# Technical Service Bulletin

## 91 Navigation plus (RNS-E) poor AM reception

91 14 65 2037125/2 October 3, 2014. Supersedes Technical Service Bulletin Group 91 number 14-43 dated May 2, 2014 for reasons listed below.

Model(s)	Year	VIN Range	Vehicle-Specific Equipment
TT	2014 - 2015	All	Radio Navigation (RNS-E)

Figure 1. Aerial amplifier 2 -R111-.

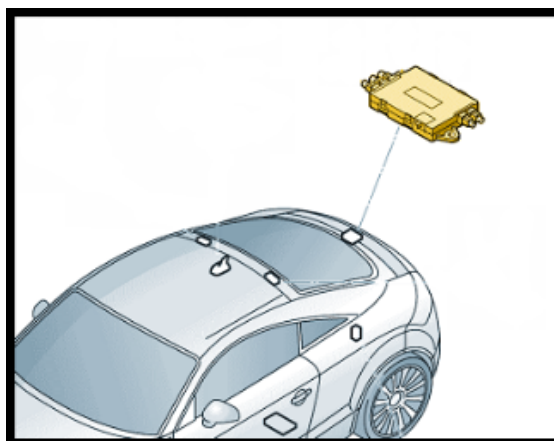
The poor AM radio reception is due to an internal hardware issue of aerial amplifier 2 –R111- (Figure 1). All service parts have been checked and faulty parts were cleared out of stock.

Optimized hardware for the aerial amplifier was implemented into series production.

Figure 2: TT Coupe rear lid trim.

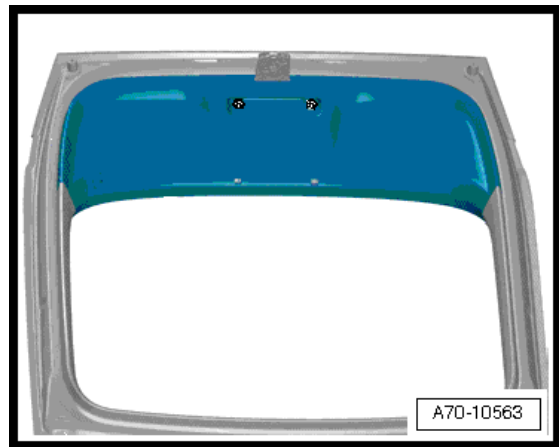
Remove the rear lid lower trim panel (Figure 2) according to the Elsa repair manual (*Body>>Body Interior>>70 Interior Trim>>Removal and Installation>>Luggage Compartment Trim Panels>>Rear Lid Lower Trim Panel*).

Figure 3: TT Roadster rear bumper cover.

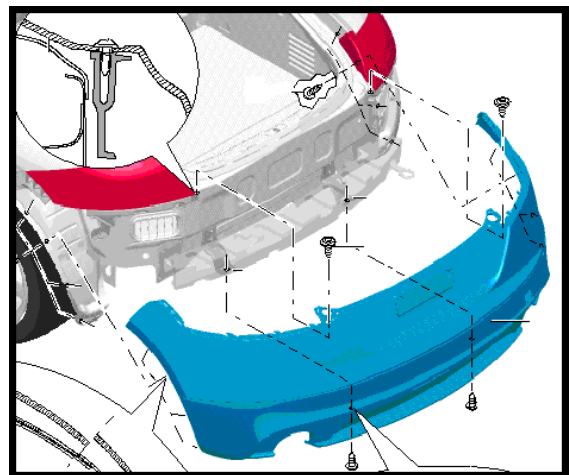
Remove the rear bumper cover (Figure 3) according to the Elsa repair manual (*Body>>Body Exterior>>63 Bumpers>>Removal and Installation>>Rear Bumper Cover*).
